SSD 10375 (Pitt St North) Stage 2 Development Application – Advice on EIS

Thank you for your correspondence dated 16 July 2020 seeking the City of Sydney's (the 'City's') comments on the above detailed design for the Pitt Street North OSD at 175-183 Castlereagh St, Sydney.

Figure 1: Snapshot from Appendix V1 Transport Report (Figure2-4)

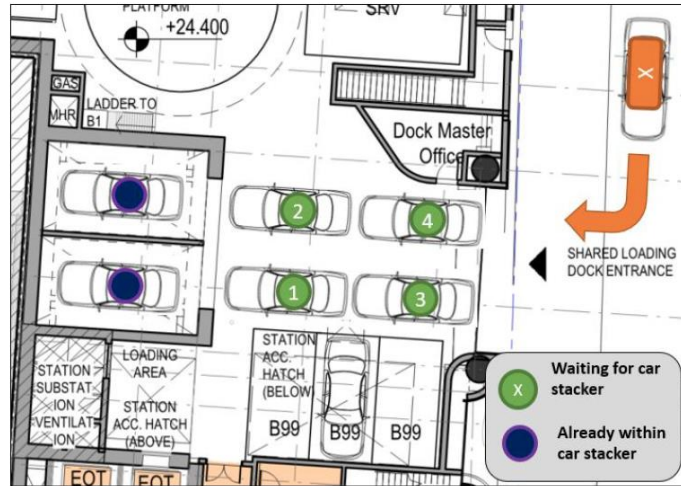
The vehicle access and queuing arrangements are unclear. Limited space is provided for vehicle waiting, queuing and manoeuvring. Vehicular access arrangements must be redesigned to reduce the need for vehicles to queue on the street to enter the site or by moving loading and servicing vehicles on street, which would impact on the busy footpath, street and bus lane. In addition, a cycleway along Castlereagh Street is planned adjacent to the site.

The design assumes all vehicles will travel in the same direction, at the same time, which will be difficult to manage. The proposed usage of the lifts, in AM for inbound flow and PM for outbound flow, would not be guaranteed, and is dependent on tenancy types. If vehicles are exiting the lift, the proposed waiting arrangement will not work (see Figure 1 below).

The design proposes that vehicles wait:

1. In front of the vehicle lifts (1 and 2 in Figure 1 below);
2. In front of vehicle parking/loading areas (1, 2 and 3) which impacts on loading; or
3. Immediately inside the driveway (3 and 4) which impacts on vehicles entering and exiting the site.

The queuing analysis for the site should follow the Australian Standards, which requires 98% of the vehicles to queue within the site. It does not appear that the 98% onsite queue requirement has been achieved in the current proposal.

The vehicle queue calculations must take into account all of the mechanical installations – vehicle lift/s, turn table/s, and stacker system.

- If these mechanical parking installations are considered in the system, the specification data sheet (vehicle lift operation speed, vehicle retrieval time from the stacker, turntable operation time etc.) from the manufacturer / written confirmation must be supplied.
- A detailed and appropriate vehicle queue analysis must be submitted and the required number of waiting areas shown clearly on the plan. The required waiting areas should not impact on access to and from the site.

Figure 2: Snapshot from Appendix v1 Transport Report (Figure4-6)

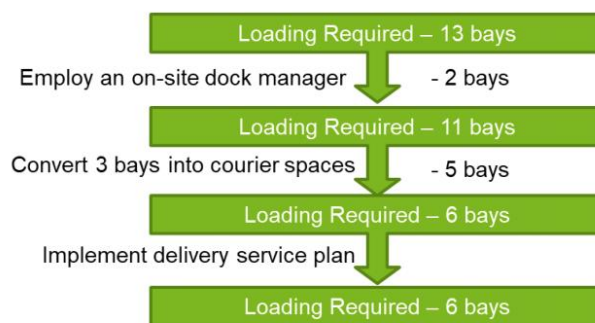
The proposal does not comply with *Schedule 7, 7.8.1 Service Vehicles* of the Sydney DCP 2012. Notionally, 21 servicing and loading bays would be required (excluding the space for the Metro). It is unclear if all 6 loading bays can be used at the same time.

Justification for the shortfall as shown in Figure 2 below requires further explanation – for example, how have the deductions in spaces been determined? The SDCP 2012 rates include a mix of courier and other bays therefore it is not clear how converting 3 bays into 3 courier bays equates to a reduction of 5 loading and servicing bays.

We also note that the 3 courier bays are accessed via vehicle lift and automatic stackers, which limits their use as they should not be used by visitors. And, the traffic report mentions different maximum use rates for the loading and servicing areas. These should be consistent.
